As requested during the audit, ISRS of the center nodes of four walls in the auxiliary building are compared between ANSYS Coarse and ACS SASSI models. The selected four walls are presented in Figures 1 through 4.

Figure 1. Selected Wall at Level 5 of AB for ISRS Comparison

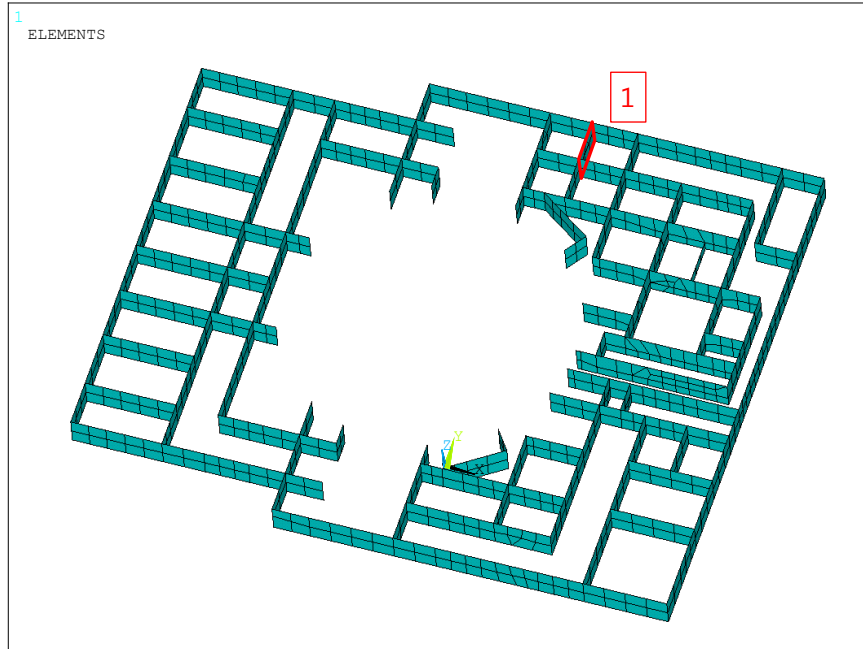
For the No. 1 wall, it is expected that the ISRS obtained from the ACS SASSI model are more reasonable because the acceleration value of the second peak in the X-directional ISRS of the ANSYS model corresponding to the out-of-plane direction is greater than the acceleration value of the first peak corresponding to the major natural frequency of the overall auxiliary building.

Figure 2. Selected Wall at Level 6 of AB for ISRS Comparison

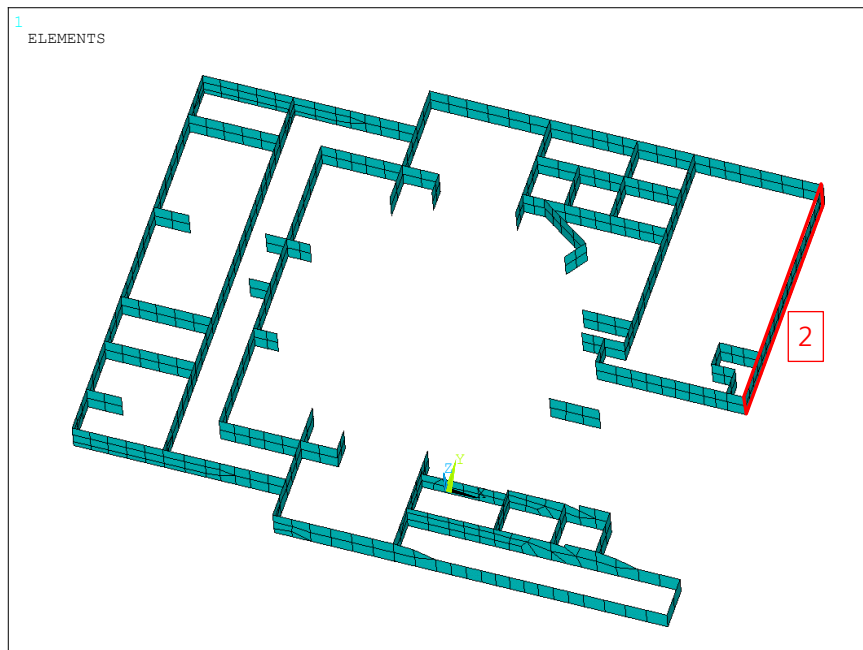
As shown in the comparison figures above, the ISRS of No. 2, 3, 4 walls show close agreement between ANSYS coarse and ACS SASSI models. Although there are some differences between the spectral peaks of the ANSYS and ACS SASSI results, the differences are attributed to the equivalent damping with Rayleigh damping coefficients used in the ANSYS models to approximate the ACS SASSI damping ratios.
